Final Environmental Impact Report

The Derby Mixed-Use Project

STATE CLEARINGHOUSE NO. 2022100298

OCTOBER 2023

Figure 5
Proposed Project Trip Distribution
Derby Mixed Use Project

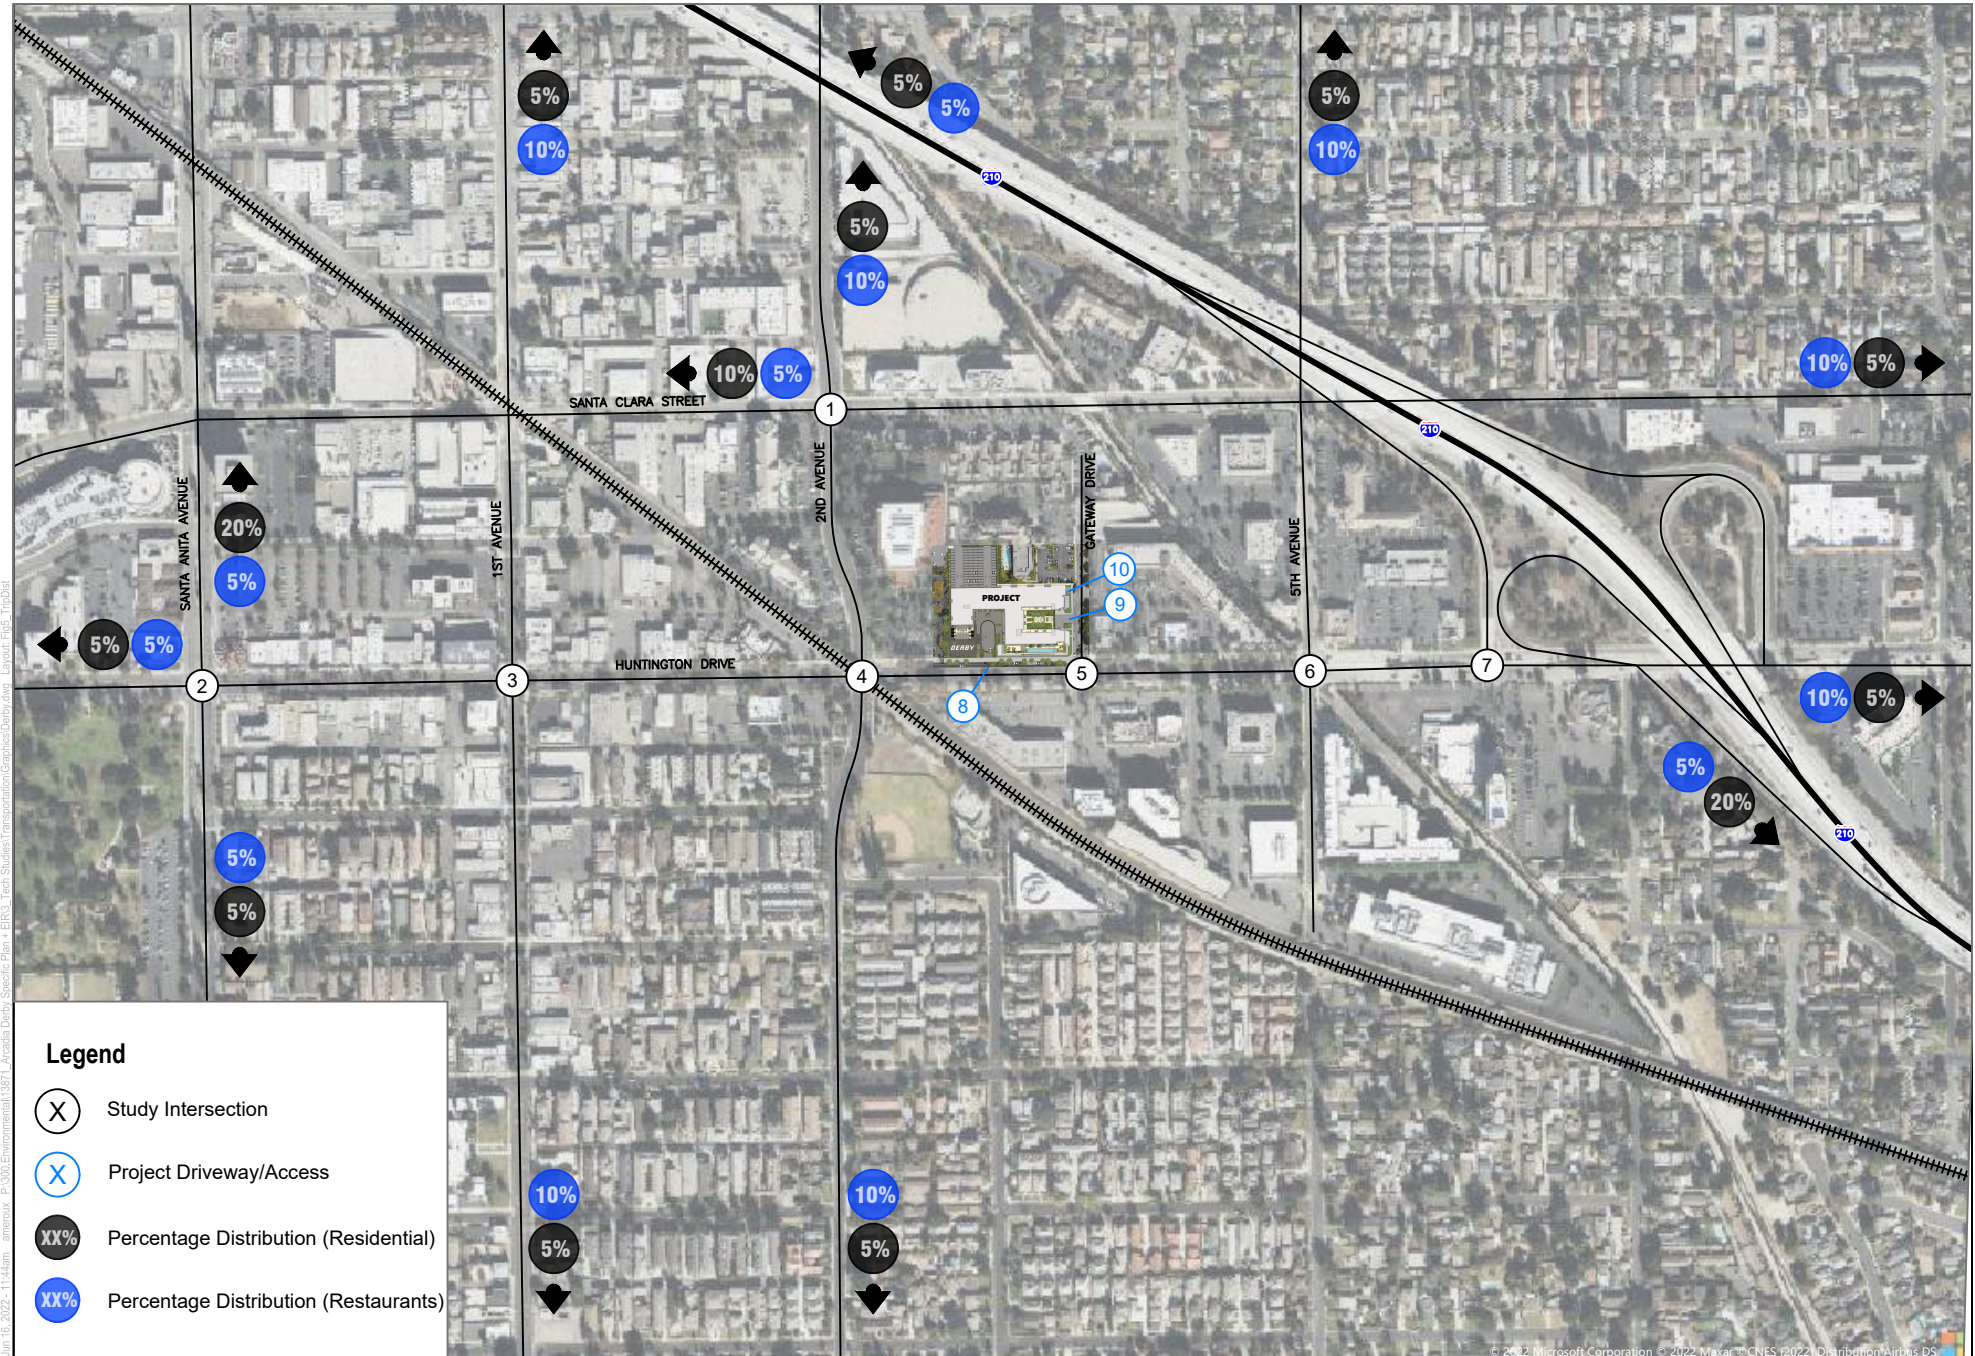
The comment notes that a letter in response to the NOP dated November 9, 2022, requested a queuing analysis at the eastbound/westbound off-ramps on I-210 to Huntington Drive and that no queuing analysis was prepared in the Draft EIR. The comments notes that Caltrans is most interested in the westbound off-ramps on I-210 to Huntington Drive.

Additional traffic data was provided to Caltrans on September 22, 2023 (via email) summarizing the number of potential Project trips estimated to use the I-210 eastbound and westbound off ramps at Huntington Drive during the morning and afternoon peak hours. The data shows that the Project would add a total of 5 peak hour trips (AM and PM) to the I-210 eastbound off-ramp and a total of 7 AM peak hour trips and 12 PM peak hour trips to the I-210 westbound off-ramp. As a follow up to the information received, Caltrans provided the following response via email on October 3, 2023:
